II. EAW NOTIFICATION AND DISTRIBUTION

IV. SUBSTANTIVE COMMENTS RECEIVED AND RESPONSES TO THESE COMMENTS

Final Findings of Fact and Record of Decision for the Environmental Assessment Worksheet for the Pillsbury A Mill Project

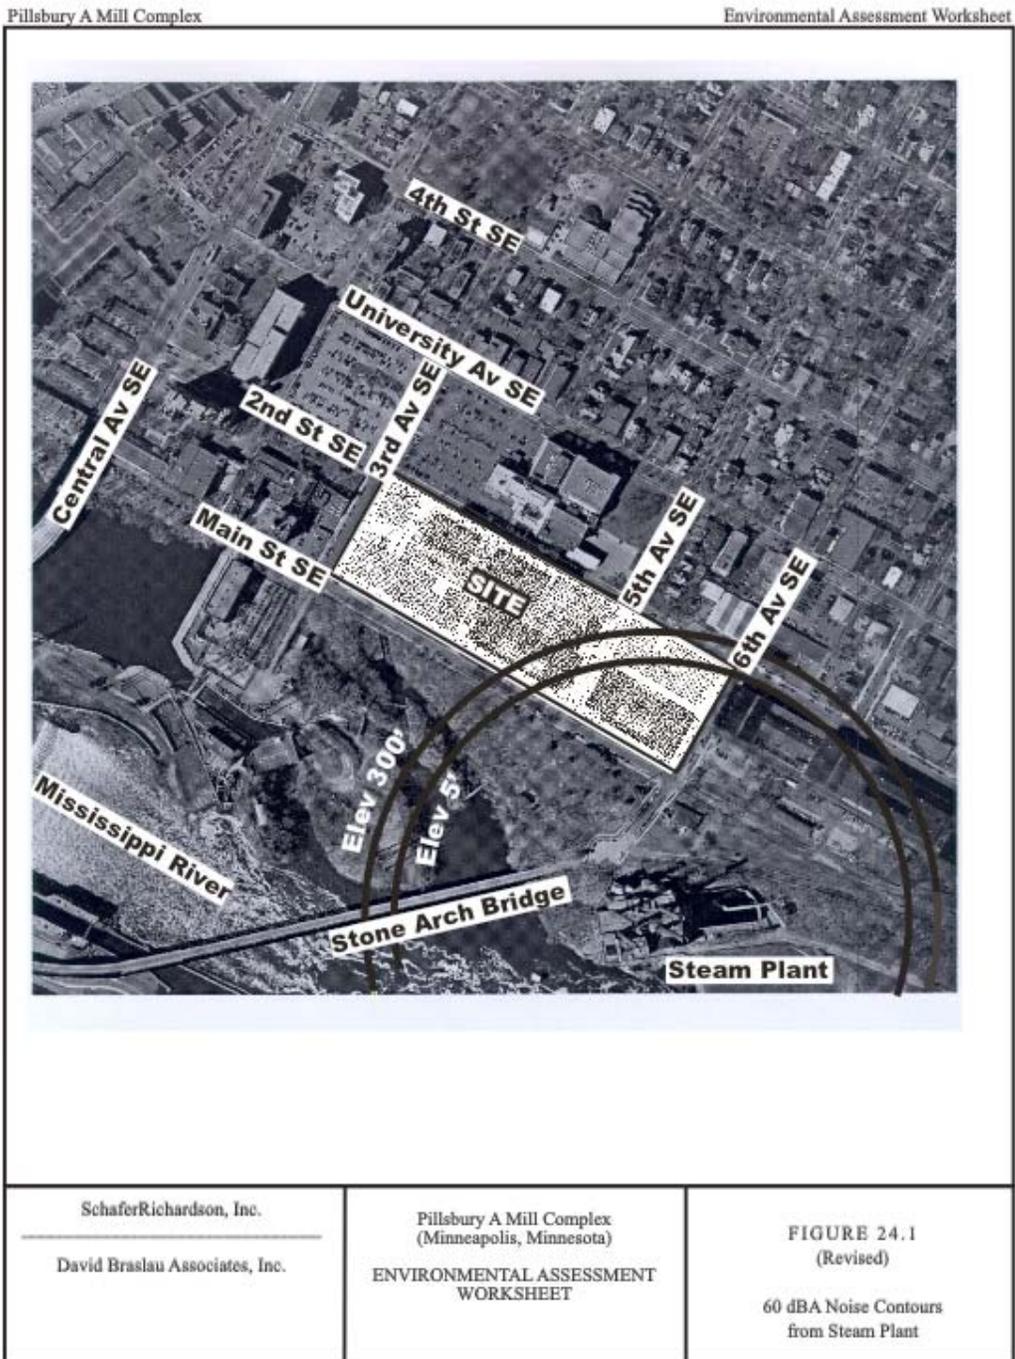
The University of Minnesota: The University is concerned the proposed residential development in this industrial area may be incompatible with operation of the steam plant

Determination of Stack Height: An extensive review of the Environmental Impact Statement, air emission permit and supplements to the permit was needed to establish and confirm the height above Main Street of the University of Minnesota steam plant stacks. Various heights were identified in the documents ranging from 213.3 feet to 263.8 feet. From the first supplement to the application (1 December 1994) "The Southeast Plant stack heights in the model were increased to 80.42 m (263.8 ft) to reflect actual dimensions." "The original modeling used stack heights of 65 m (213.3 ft) (the deminimis height) from a base elevation of 235.66 m (773 feet) which were taken from the MPCA's source inventory list. In the revised modeling Foster Wheeler has obtained and used actual building dimensional elevations." Therefore, since the Main Street elevation is 812 feet, the actual height of the stacks is 225 feet above grade as confirmed in the second supplement to the permit (12 April 1996) "The plant has four identical stacks situated on the Southeast Plant roof, which are approximately 225 feet above grade and 14 feet in diameter. Two are currently being utilized, one each by Southeast Plant Boiler #3 and #4." The stack height assumed in the EAW was erroneously based upon an earlier estimate.

The adjusted heights of buildings relative to the actual stack height are shown in the table below. It can be seen that only two of the proposed buildings will be higher than the stack.

Effect of Increase Stack Height on Air Quality and Noise: The stack height is 15 feet below the tallest proposed structure on Parcel F and 72 feet below the tallest proposed structure on Parcel E. The effective stack height for air emissions, due to plume rise associated with temperature and exit velocity of the stack flow can be considerably higher than the actual stack level. The estimated effective stack height for Boiler #3 is 287 feet while that for Boiler #4 is 307 feet, so that only the Boiler #3 effective stack height will be lower than the proposed building on Parcel E (297 feet above grade).

The greater stack height effects noise level in two ways. The 60 dBA level at 5' above the ground will be further from the stack due to the slant distance effect of extrapolating the sound level observed at a distance of 400 feet from the stack. The 60 dBA level at 300' above the ground will be closer since the increase in radiated sound level above the stack opening begins 85 feet higher than previously assumed. The 60 dBA contours (at 5' and 300' above grade) are shown in a revised Figure 24.1. The virtual sound source for these schematic contours has also correctly relocated to the steam plant stacks.

Except for Parcels F and G, sound levels are expected to be below 60 dBA at all heights. Levels at Parcels F and G may be as high as 62 to 63 dBA, but will not exceed the L50 65 limit of the NAC-2 classification, requiring an exterior-to-interior noise reduction of 30 dBA. Upper level balconies may be enclosed because of wind. Lower level balconies may be exposed to levels just over the daytime standard.
